1600 HAMPTON ANNEX – RENOVATION (DLES)

PROJECT NO: H27-I997
USC PROJECT NO: CP00345233
JCS PROJECT NO: 12113

ADDENDUM 01
March 26, 2014

DATE: 3/18/2014	TITLE: Sprinkler Demolition Plan - Basement	REFERENCE SHEET: FP2	JOB: 1600 Hampton Annex- Renovation (DLES)	ADD#01 SHEET NO.: FP2
--------------------	---	-------------------------	--	-----------------------------

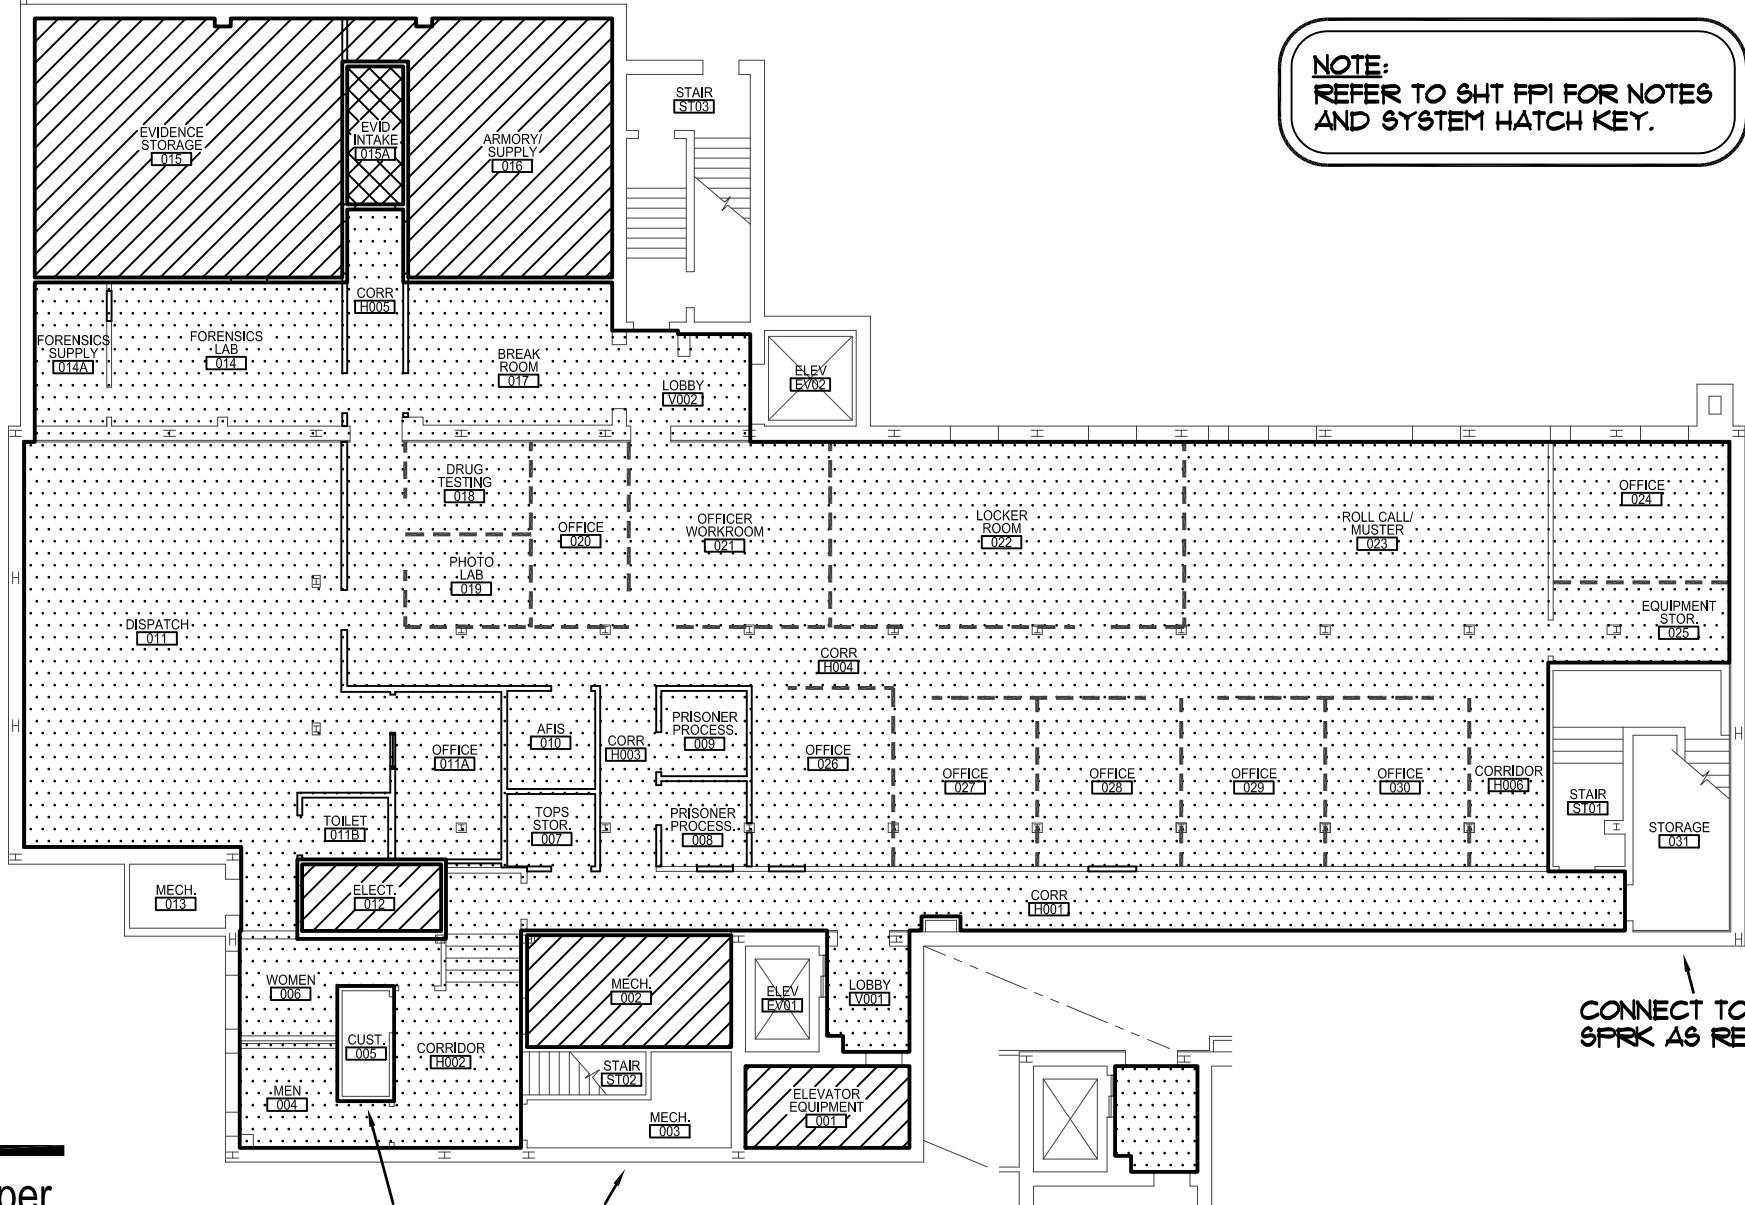
1. Refer to the attached 8-1/2" x 11" sketches FP1, FP2 and FP3 for drawing scope related to the modifications to the existing wet-pipe sprinkler systems presently installed in the basement areas and 1st floor elevator lobby.
2. Provide all piping modifications and work for all areas of the basement and 1st floor elevator lobby as indicated. (See specifications included with this addendum.)

CONNECT TO EXIST
SPRK AS REQUIRED

E201

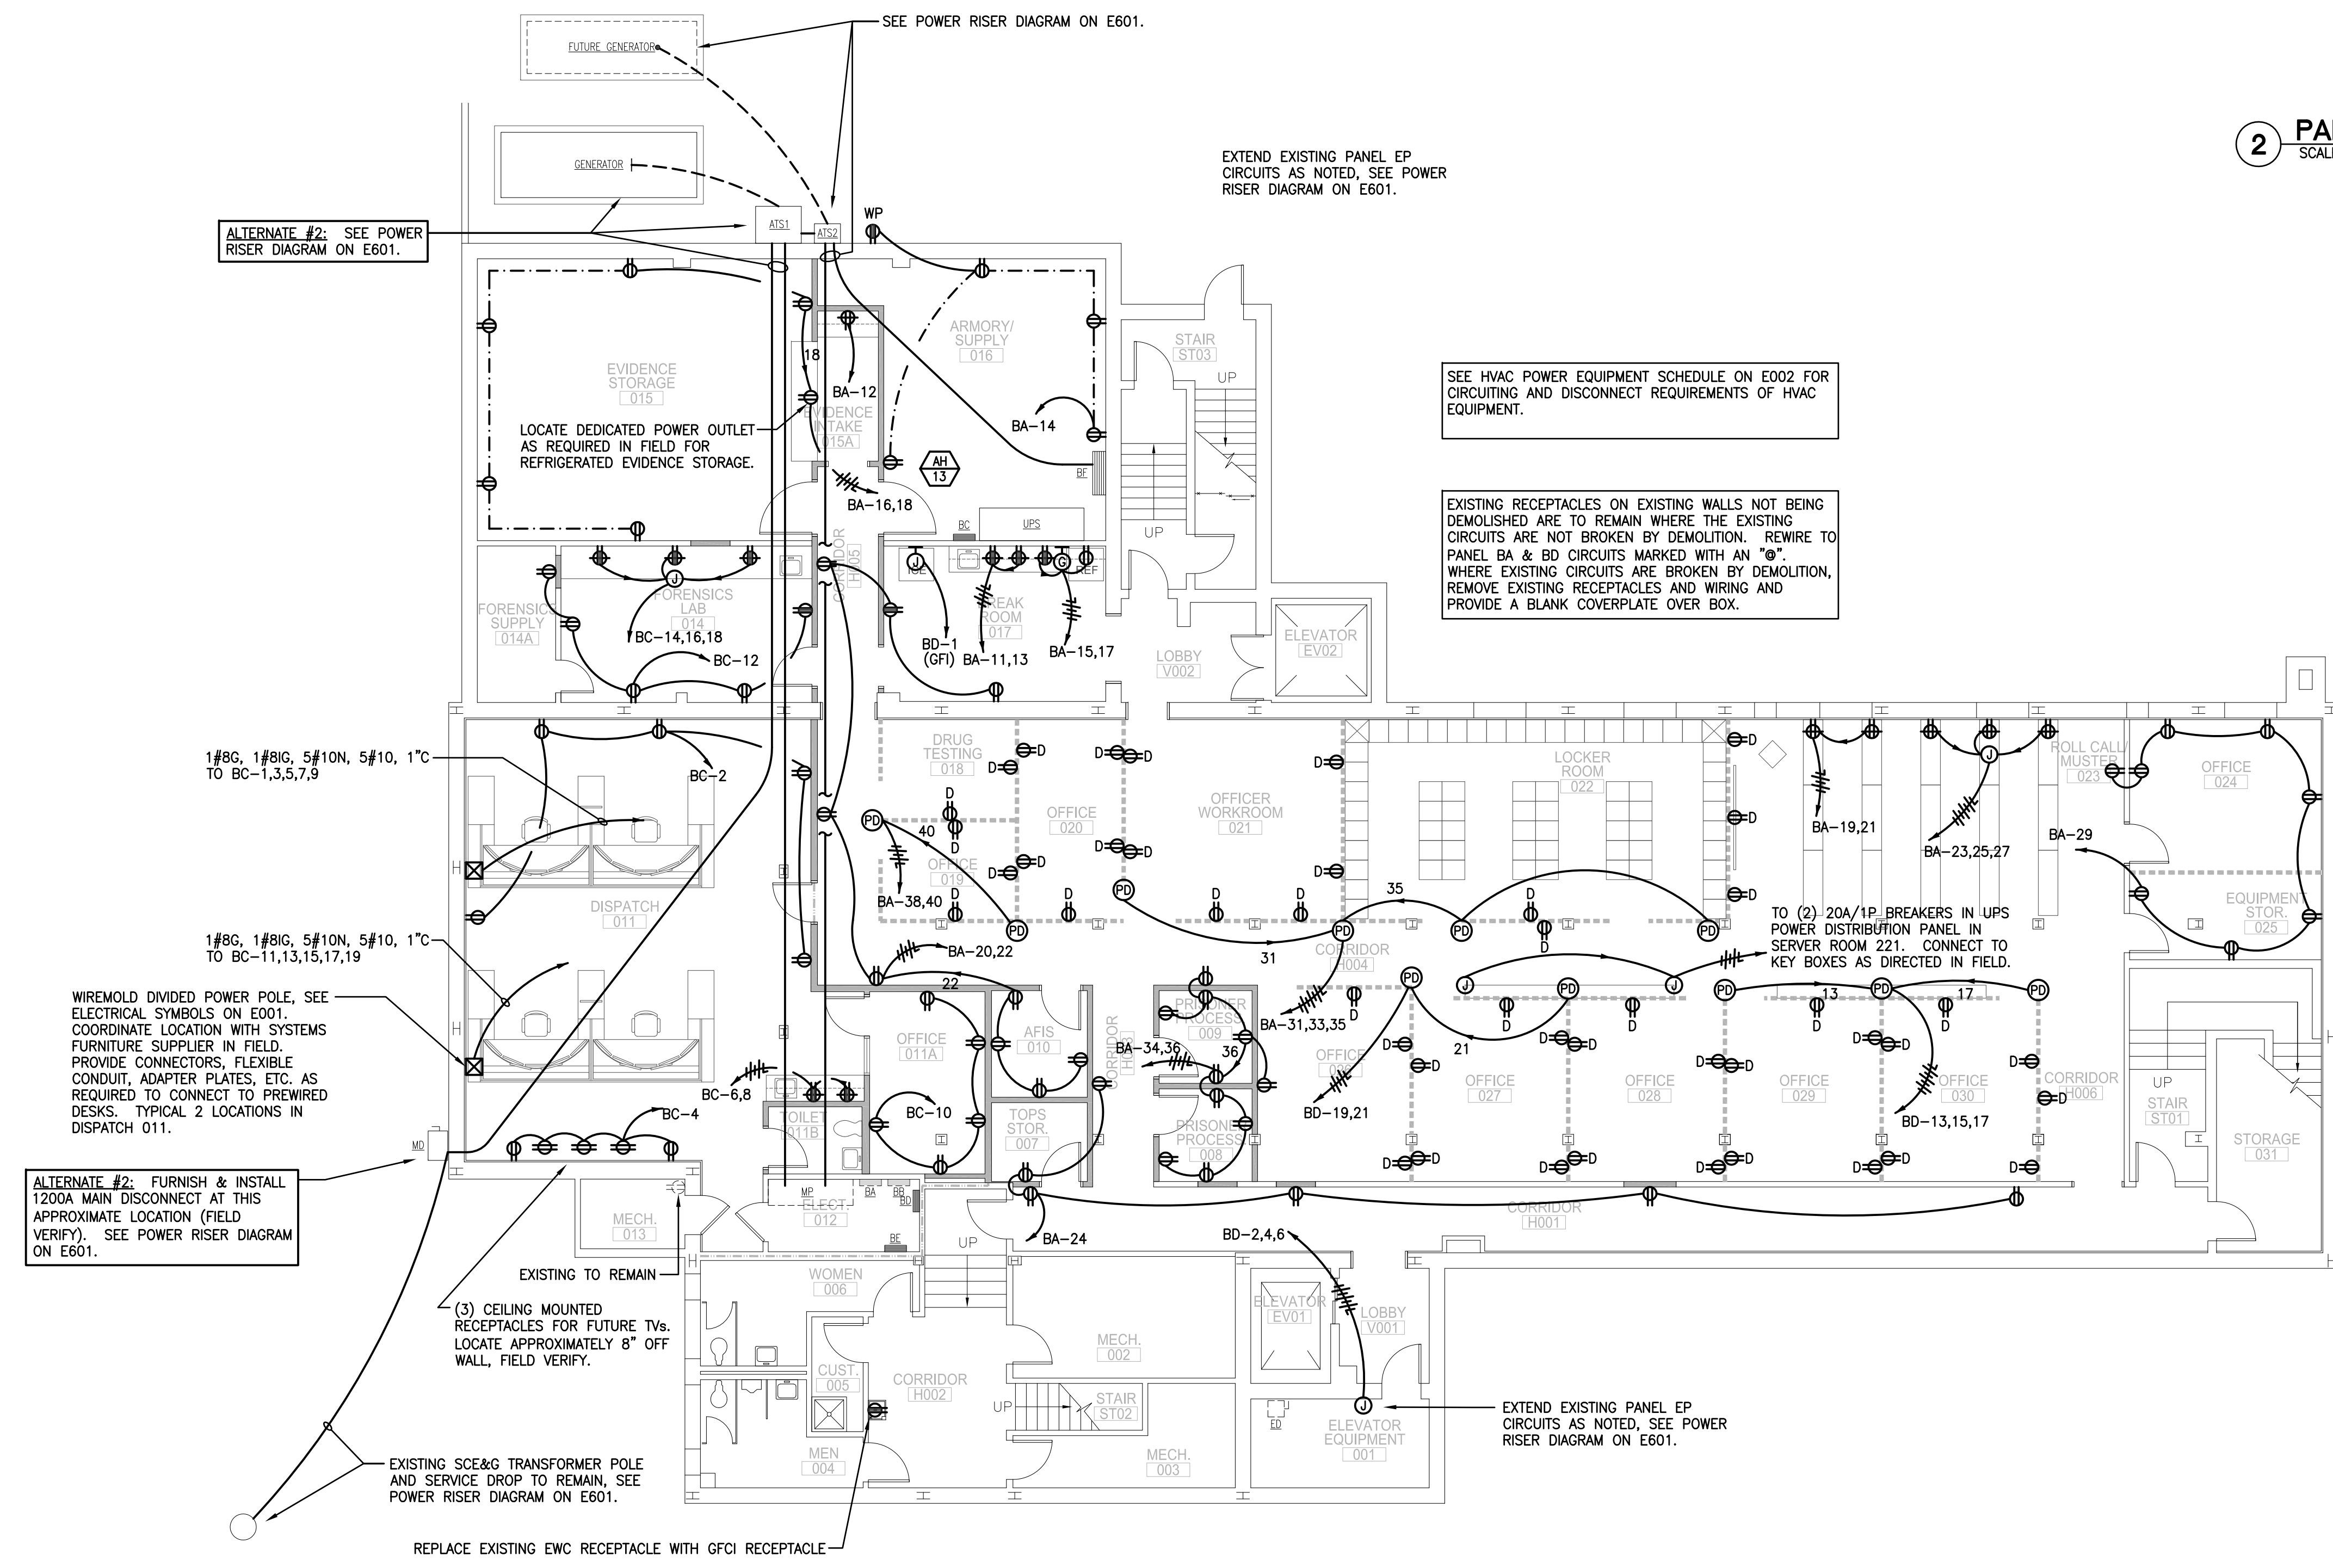
Rework the existing electrical service as noted on Sheets E201, E600, and E601. Work under this alternate includes addition of a 1200A fused main disconnect switch, rerouting of the 1200A main feeder from the 1200A main disconnect switch to ATS1 located at rear of building, and from ATS1 to existing Main Panel MP. ATS1 to be furnished and installed under a separate contract.
